UNITED STATES ENVIRONMENTAL PROTECTION AGENCY
REGION 6
1445 ROSS AVENUE, SUITE 1200
DALLAS, TX 75202-2733

The Environmental Protection Agency (EPA) Region 6 has reviewed Public Notice (PN) SWG-2009-00991, dated May 8, 2014. The project is located on the north side of the Tule Lake Channel, approximately 4.25 miles WNW of the Harbor Bridge, in Corpus Christi, Nueces County, Texas. The project can be located on the U.S.G.S. quadrangle map entitled: CORPUS CHRISTI, Texas. Latitude: 27.82623 NORTH; Longitude: 97.48413 West.

The applicant, CCI Corpus Christi, LLP, proposes to construct and operate a new condensate splitter facility which includes a bulk petroleum terminal. The facility would be constructed on an 82-acre tract of land and would also include two ship docks and one barge dock located on the Tule Lake Channel of the Corpus Christi Ship Channel (CCSC) for condensate shipment receipt and product loading.

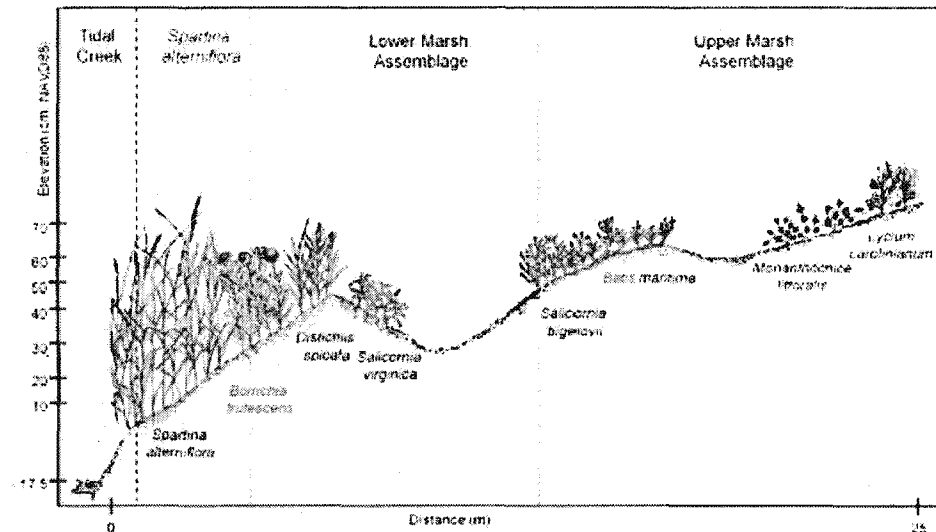
- We question the mitigation value of the proposed planting of smooth cordgrass (*Spartina alterniflora*), black mangrove (*Avicennia germinans*), Virginia glasswort (*Salicornia virginica*), turtleweed (*Chlorodesmis fastigiata*), saltgrass (*Distichlis spicata*), chairmaker's club-rush (*Schoenoplectus americanus*) and associated species in unvegetated areas along the banks of Rincon Bayou. First, is planting necessary? Why aren't the elevations proposed to be planted naturally vegetated? If the answer to the former question is "yes", then are these the correct species to plant (see the following, from Hodges et al. 2012)?

Based on the above information, we question whether black mangrove (*Avicennia germinans*), turtleweed (*Chlorodesmis fastigiata*), or chairmaker's club-rush (*Schoenoplectus americanus*), are appropriate for planting here. Perhaps more importantly, we wonder why *Chlorodesmis fastigiata* is being considered for this site at all, as it is a filamentous green alga found on coral reefs in the Pacific Ocean. We also question whether *Salicornia bigelovii*, *Batis maritima*, *Monanthochloe littoralis*, and *Lycium carolinianum*, should also be considered for planting (if planting is actually found to be appropriate). Also based on the above information, it will be important to plant at the correct elevations. Finally, the applicant should only receive credit for the functional lift of this site attributable
